**Initial Appraisal
Sacramento River
Flood Control Project
(Glenn-Colusa), California**

INITIAL APPRAISAL

SACRAMENTO RIVER FLOOD CONTROL PROJECT (GLENN-COLUSA), CA

SACRAMENTO DISTRICT TECHNICAL REVIEW AND ANALYSIS

FIGURE 3
SITE PLAN

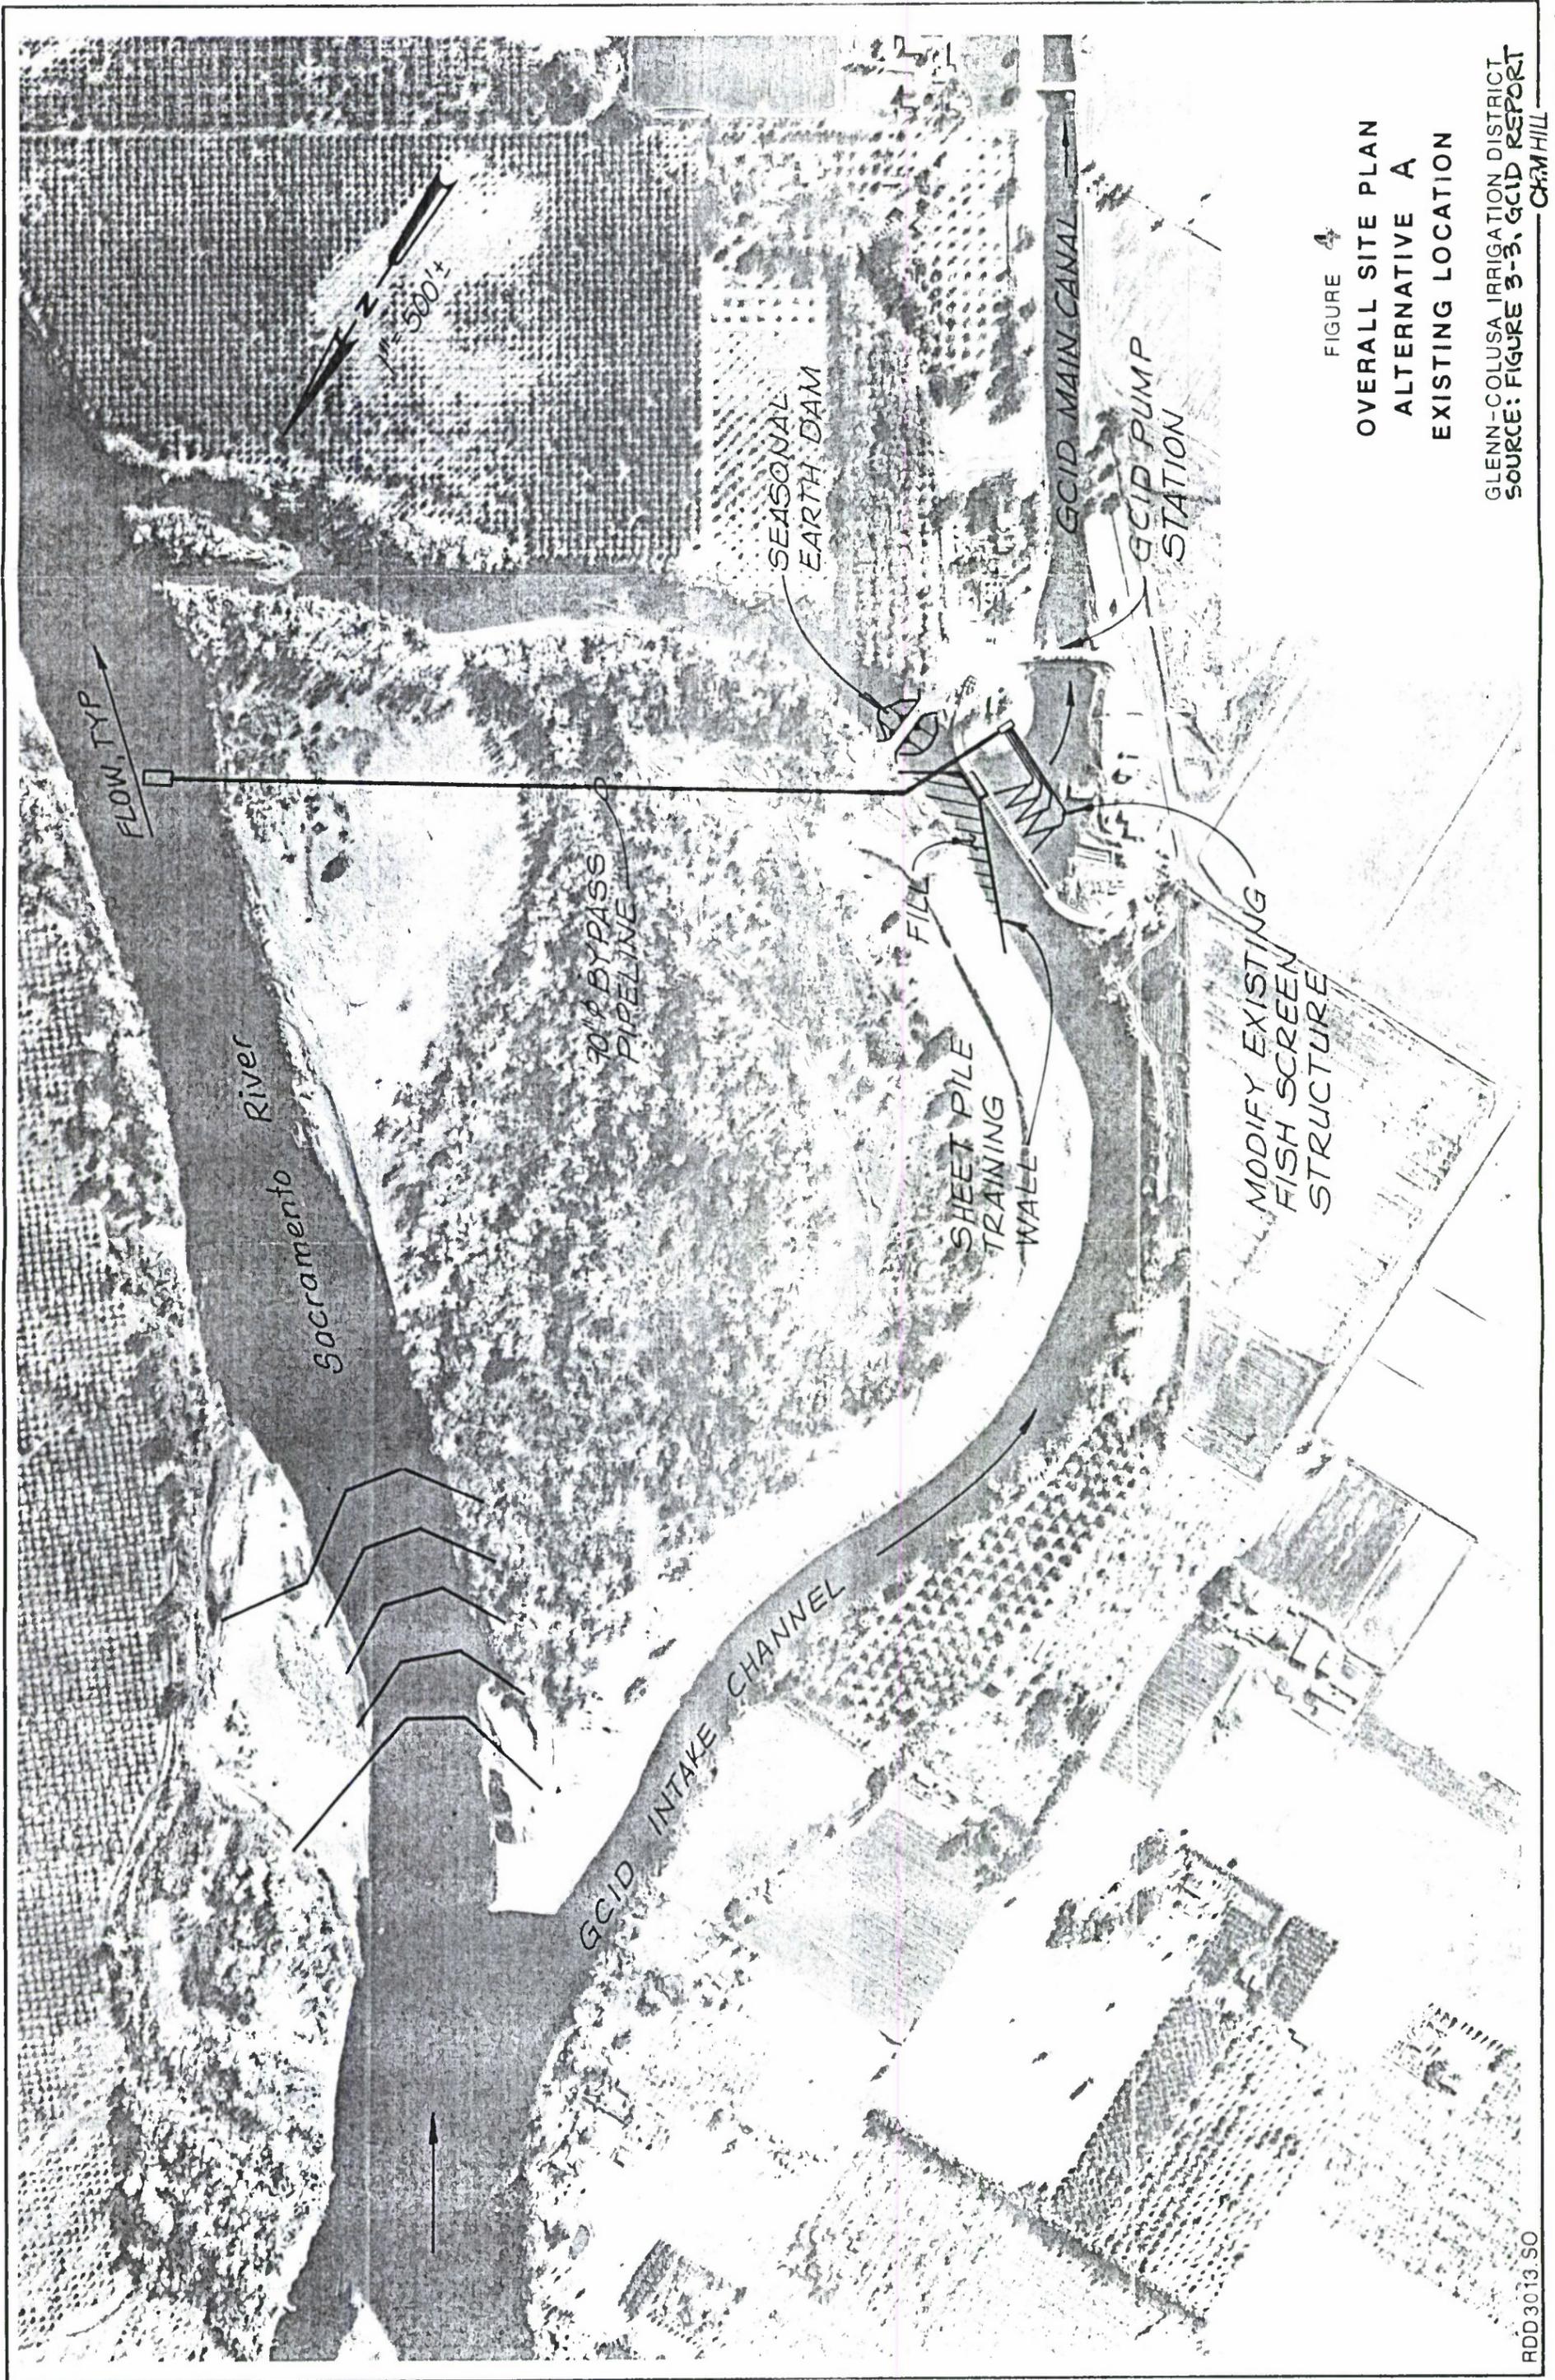
Although the GCID report is a good report that examines the most reasonable means to control the river gradient in this river reach, further study is needed for the following: (1) bank protection cost estimates, (2) additional subsurface information to determine whether the sheet piles are of correct length and width, and (3) protection measures for the riverbed between sheet-pile weirs.

The cost estimates provided in the GCID report for the gradient restoration structure and annual operation and maintenance costs are limited in detail, and require further analysis. The basic design of the structure, including the length and width of the sheet piles need to be confirmed. More extensive bank protection work may be required to prevent the river from eroding around the structure. Any improvements to the design of the structure and project mitigation measures may increase the cost of the project. Although more refined studies are required, the cost estimates in the GCID report appear reasonable for this stage of project development. After adding overhead, contingencies, engineering and design, supervision and administration, and other costs, the cost of the structure is estimated at \$5,530,000. The total project costs for all three alternatives are shown in Table 3. A slight increase in annual costs over GCID estimates occurs when an interest rate of 8-7/8 percent (rather than 8-5/8 percent) is used.

These recommended design studies and appropriate environmental documentation are estimated to cost a total of \$500,000. The design studies are as follows:
